DESIGN REVIEW BOARD DECISION ON DESIGN RESPONSE CONFERENCE APPLICATION

Date: May 28, 2013
File No.: DRV13-00192
Project Name: Lake Street Place – Phase I
Applicant: Rick Chesmore with Chesmore|Buck Architecture

ELEVATIONS
Sheet No. 3.0
Project No. 1105
Date: 07/30/12

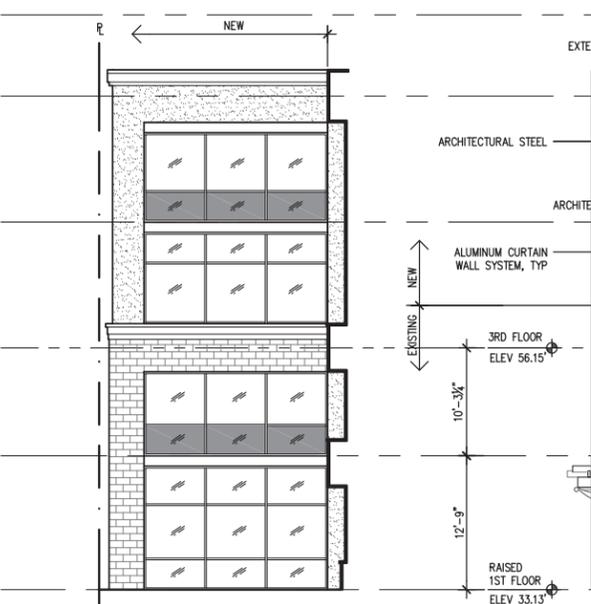
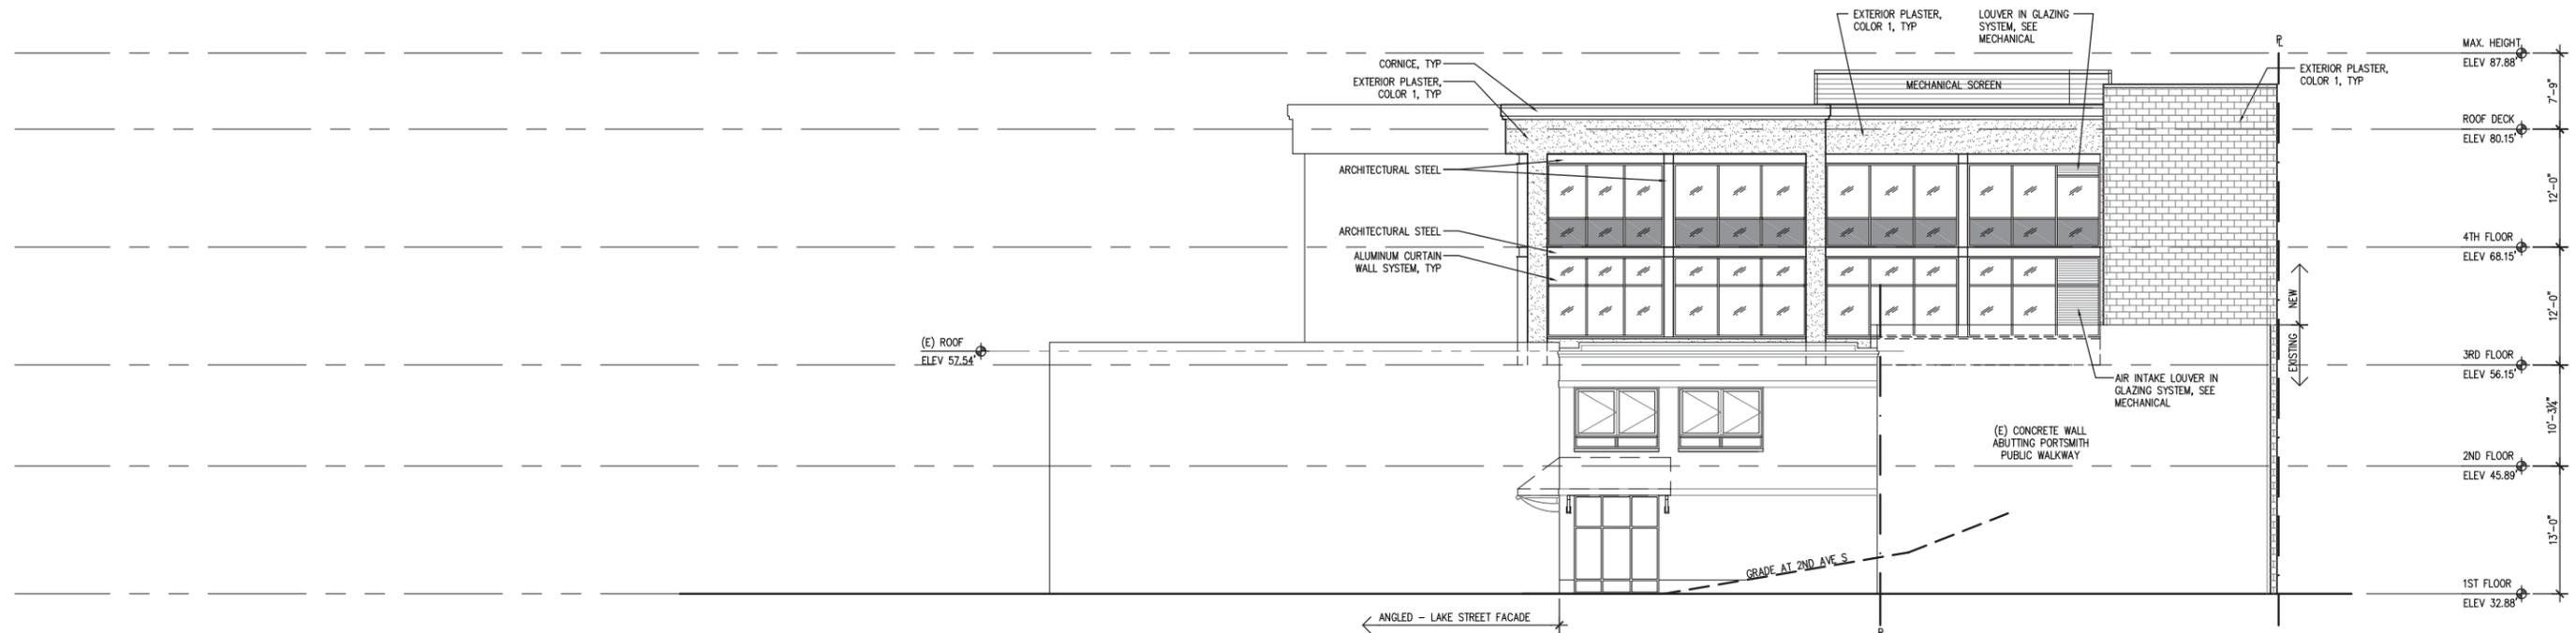
- North and northwest façade – Option C consisting of a revised window and column layout with CMU cap, horizontal band to match existing, and Hardie panel cladding at elevator tower.

2. Detailed plans that show the inside corner column to be clad with matching CMU at the 1st and 2nd story where connecting to the Milagro restaurant.

2 EAST ELEVATION
 1/8" = 1'-0"

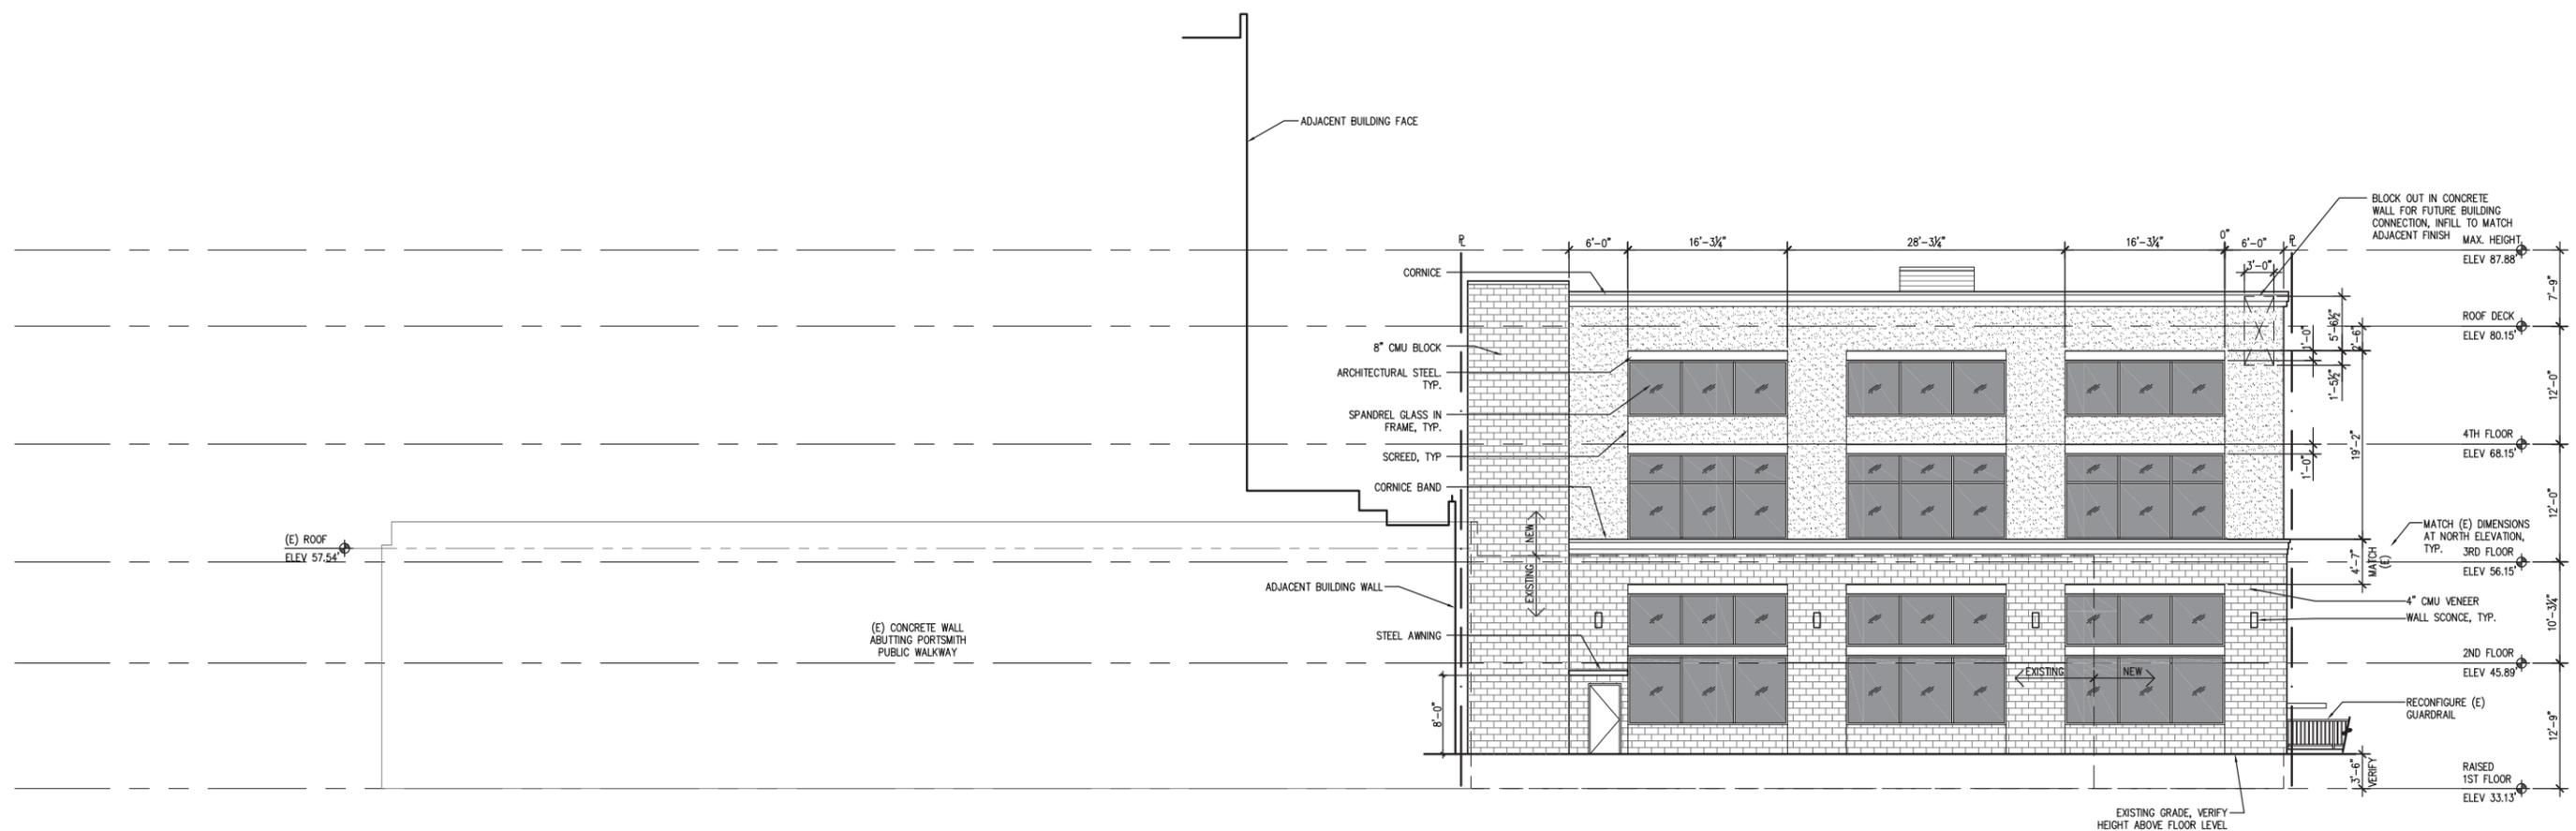
- East façade – Option 2 consisting of a revised window and column layout and 6" Hardie plank rain screen stair tower cladding.
 - South façade – Option 2 consisting of a 6" Hardie plank rain screen stair tower cladding.
